NAVIGATION - STALL WARNING HORN REPLACEMENT FOR CESSNA MODELS 182, U206, 207

The original stall warning horn is no longer available. If the stall warning horn needs to be replaced a new stall warning horn and bracket are available.

SEB-34-32
Page 1 of 9

Figure 1. Before Modification (Sheet 1)

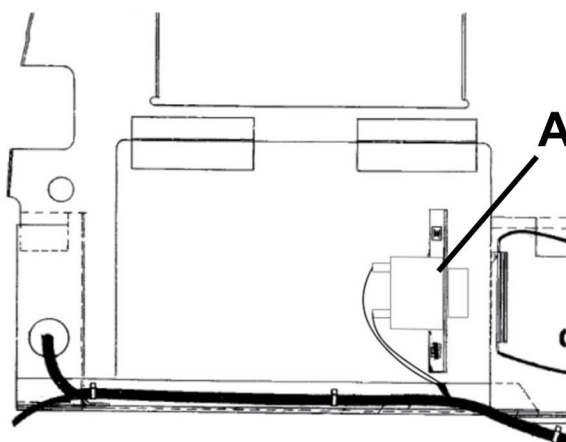
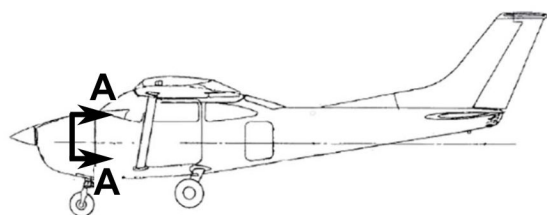
3. (Refer to Figure 1, Sheet 1.) Remove the 1670056-6/-7 Stall Warning Horn as follows:

- A. Remove and keep the two mounting screws from the 1670056-6/-7 Stall Warning Horn.

- B. Remove the nuts and washers from the studs of the 1670056-6/-7 Stall Warning Horn.

- C. Disconnect the electrical wiring from the 1670056-6/-7 Stall Warning Horn.

- D. Discard the 1670056-6/-7 Stall Warning Horn and the 0713738-3 Bracket Assembly.

Figure 2. After Modification (Sheet 1)

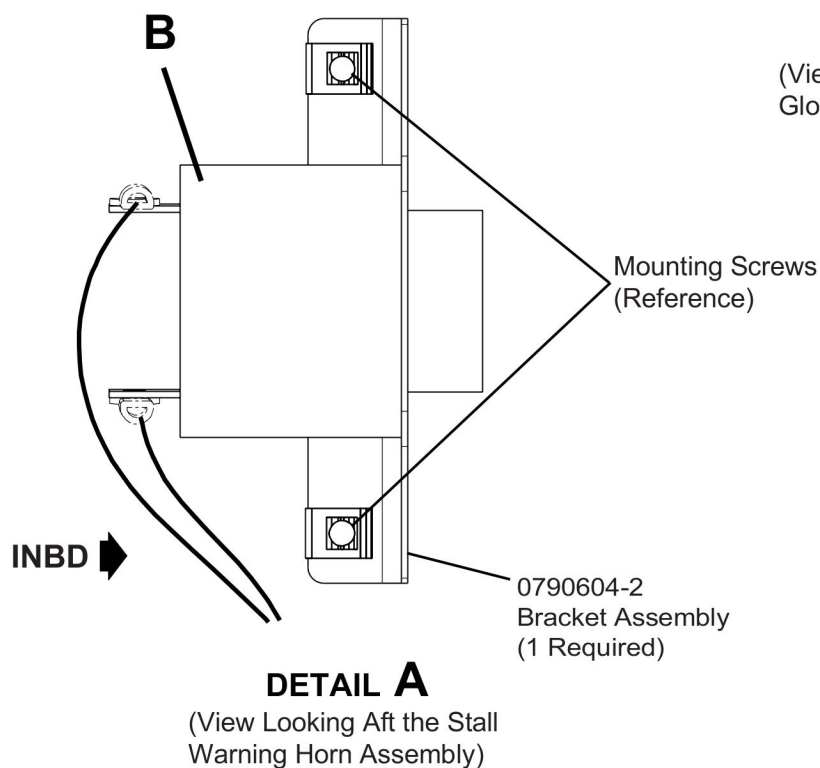
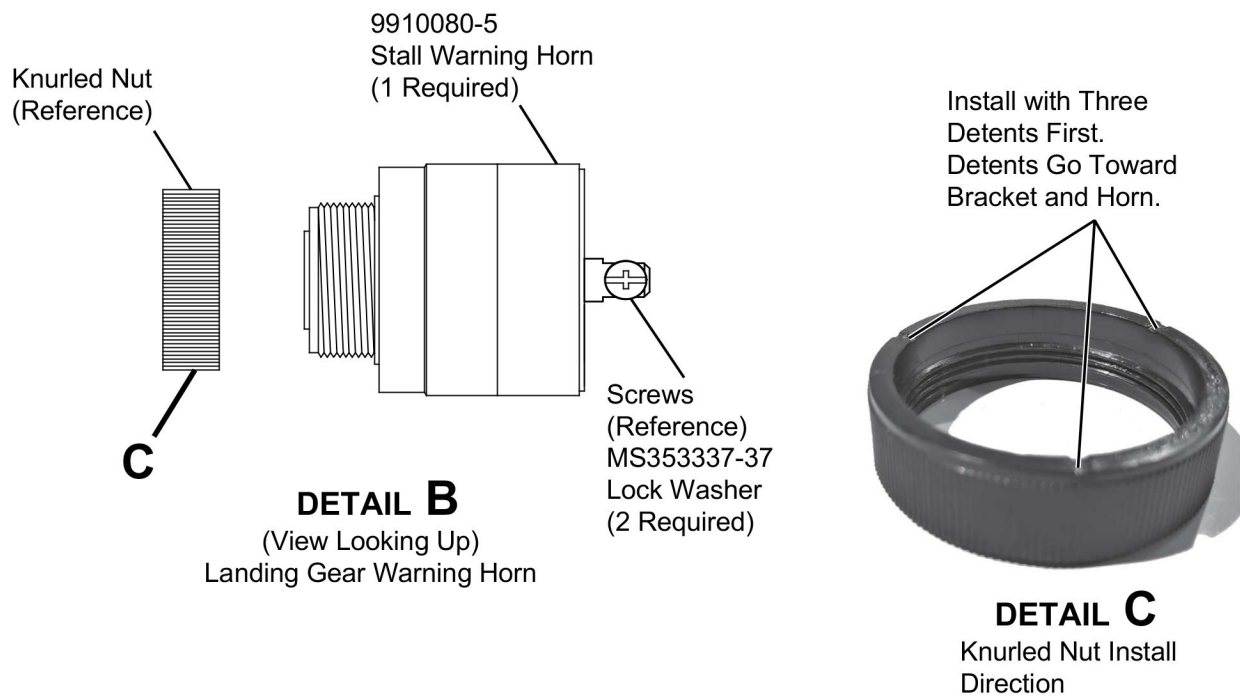
4. (Refer to Figure 2, Sheets 1 and 2.) Install the 9910080-5 Stall Warning Horn as follows:

NOTE: All installations of the 9910080-5 Stall Warning Horn will be mounted onto the forward side of the glovebox assembly.

- C. Install the 9910080-5 Stall Warning Horn into the 0790604-2 Bracket Assembly.

- D. Install the knurled nut onto the 9910080-5 Landing Gear Warning Horn.

NOTE: The plastic knurled nut must be installed with the three indents toward the bracket and horn assembly. On the internal circumference, the smooth side without threads is installed first, towards the bracket and horn. This technique of installation will make sure the nut fully seats against the bracket and not bottom-out on the threads. If not installed correctly the knurled nut will bottom-out on the threads and the horn assembly will not be fully tightened in the bracket.

- E. Install the 0790604-2 Bracket Assembly with the two kept mounting screws onto the glovebox assembly.
- F. Install the electrical wiring with one MS35333-37 Lock Washer onto each terminal of the 9910080-5 Stall Warning Horn.

Figure 3. Drilling Dimensions (Sheet 1)

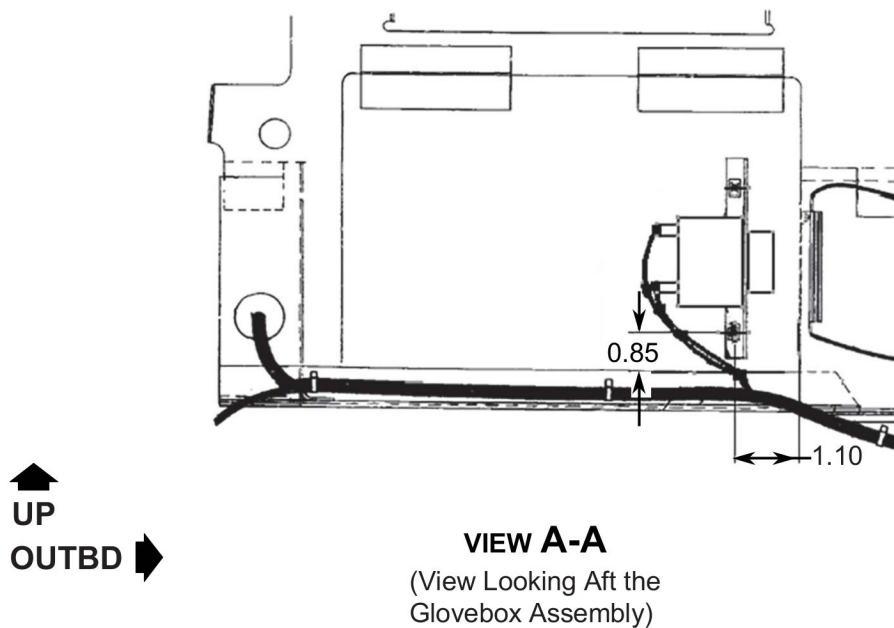
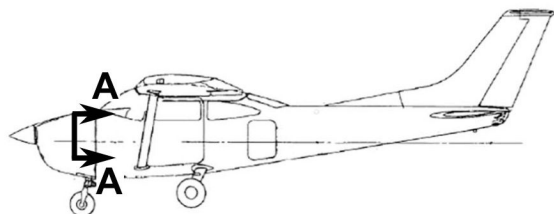
- B. (Refer to Figure 3, Sheet 1.) Match drill the two holes of the 0790604-2 Bracket Assembly to a Number 26 (0.147 inch diameter) holes into the glovebox assembly.

- (1) Deburr the drilled holes.
- (2) Apply Color Chemical Film Treatment to all bare metal.
